Exhibit B
Additions and Amendments
To the 2018 International Wildland-Urban Interface Code

(Conventions used in this document: An underscore is used to indicate new or replacement language from the model code language and ~~strikeout~~ is used to indicate model code language removed from this adoption.)

DETAIL 504.7

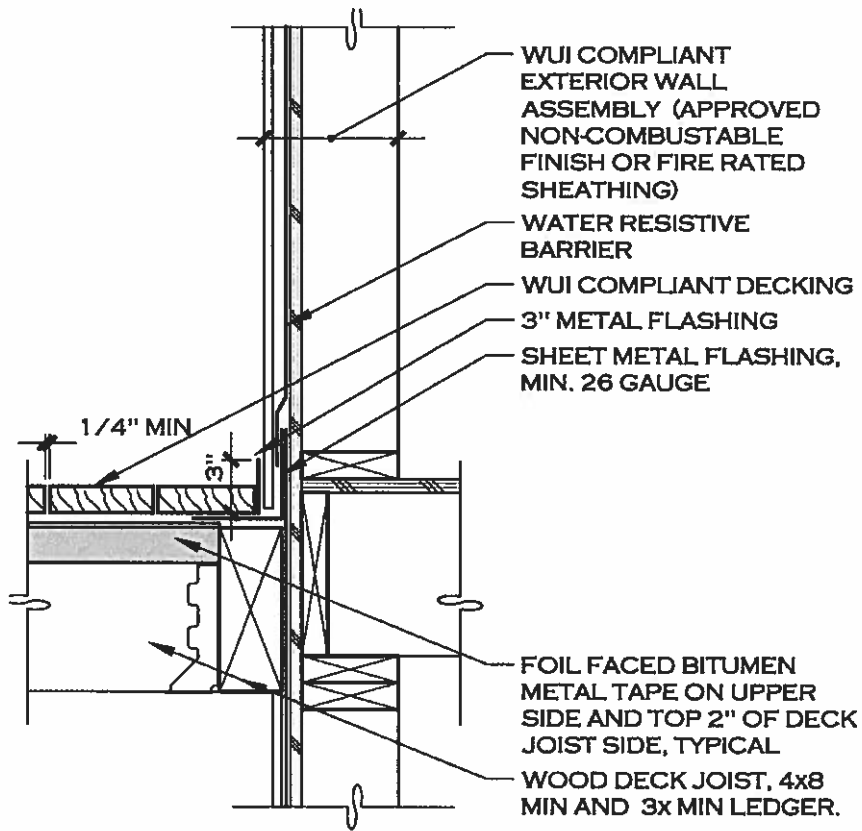
Add a new Section 504.7.2 and 504.7.3 and Detail 504.7 Decks, to read as follows:

504.7.2 Decks. All decks shall be constructed with the following:

1. Three-inch-high or greater metal flashing that is a minimum 26 gage separating the decking and combustible exterior walls.
2. Quarter inch deck board spacing with foil-faced bitumen tape or corrosion-resistant metal applied to the top and upper 2-inches of the side surfaces of the supporting joist.

504.7.3 Heavy timber construction for decks, patio covers, and similar structures defined as: Minimum 6x6 columns, 4x8 floor joists, 4x10 or 6x8 beams, 3x ledgers and 2x decking.

Add a new Section 505.7.2 and 505.7.3 and Detail 504.7 Decks, to read as follows:

Add a new Section 506.5 and 506.7.3 and Detail 504.7 Decks, to read as follows:

506.5 Decks. All decks shall be constructed with the following:

1. Three-inch-high or greater metal flashing that is a minimum 26 gage separating the decking and combustible exterior walls.
2. Quarter inch deck board spacing with foil-faced bitumen tape or corrosion-resistant metal applied to the top and upper 2-inches of the side surfaces of the supporting joist.
